DO NOT ADJUST THE DIMENSION FROM THE DRAWING			
	NAME	SIGNATURE	DATE
DRAWN BY	M.KARADELI		04.06.98
CHECKED	M.KARADELI		04.06.98
APPROVED	C.GÜLERYÖZ		04.06.98
SCALE	Item Name:		
-	17.5x6.00

**JantSa**  
 Wheel Industry & Trade Inc.Co.  
 Phone : 0 256 259 11 25  
 Fax : 0 256 259 11 24  
 AYDIN / TURKEY

DRAWING NO  
**600132**

AA-SECTION

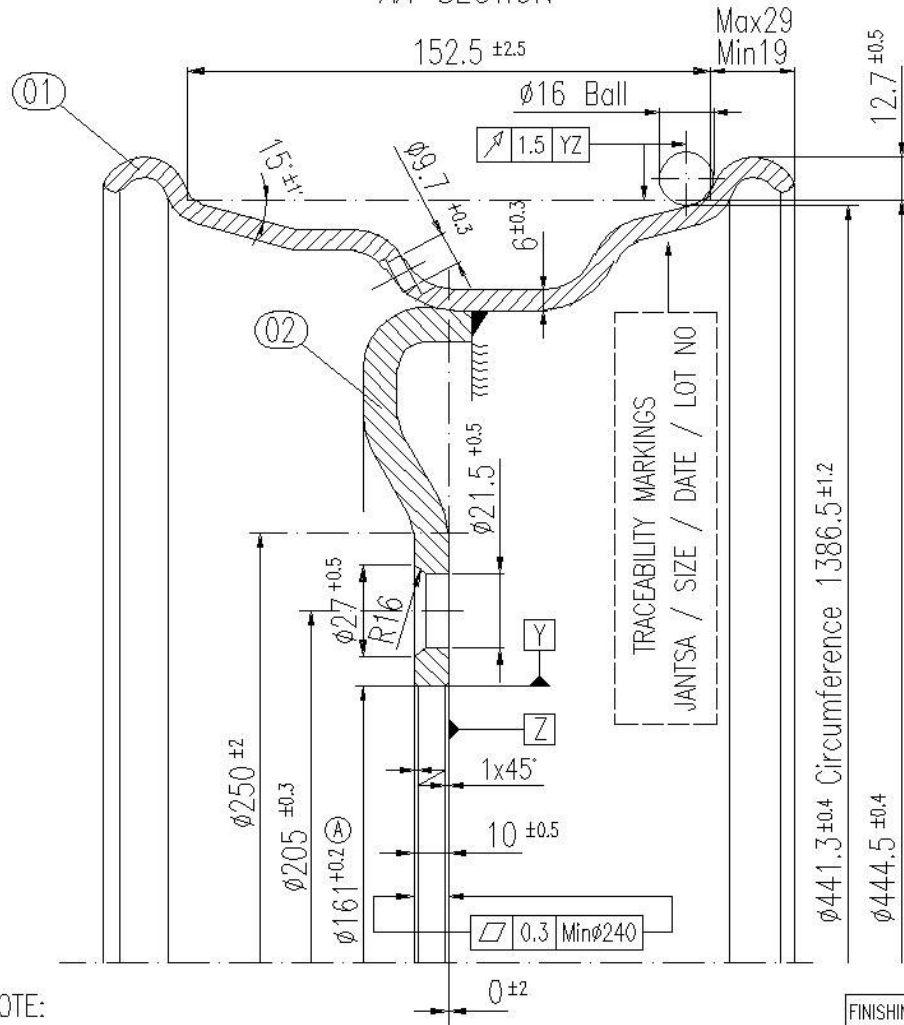
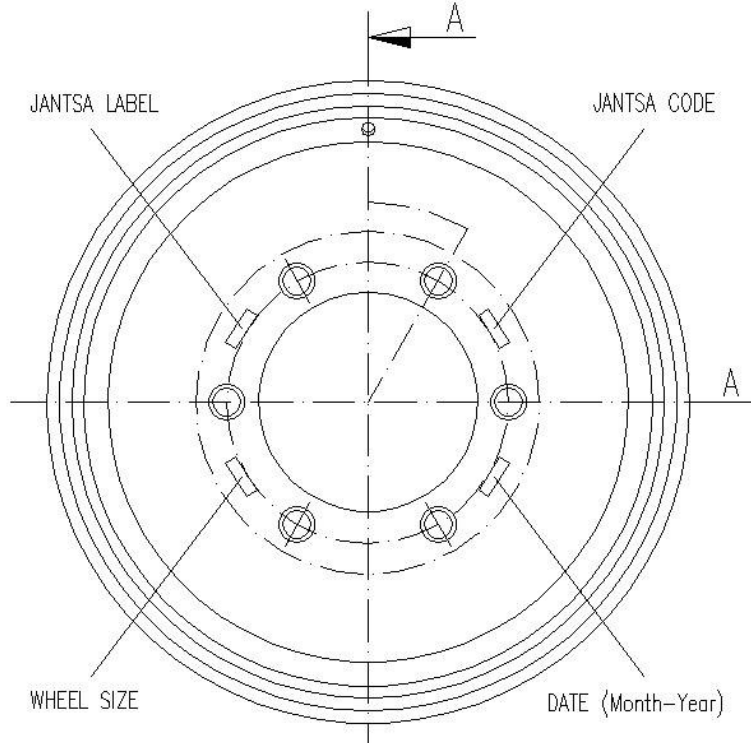
LETTER	DESCRIPTION	REVISION	DATE	REV.NO
Ⓐ	Bore hole diameter tolerance is changed. Before +1 Now +0.2	Drawing is changed.	22.12.04	1
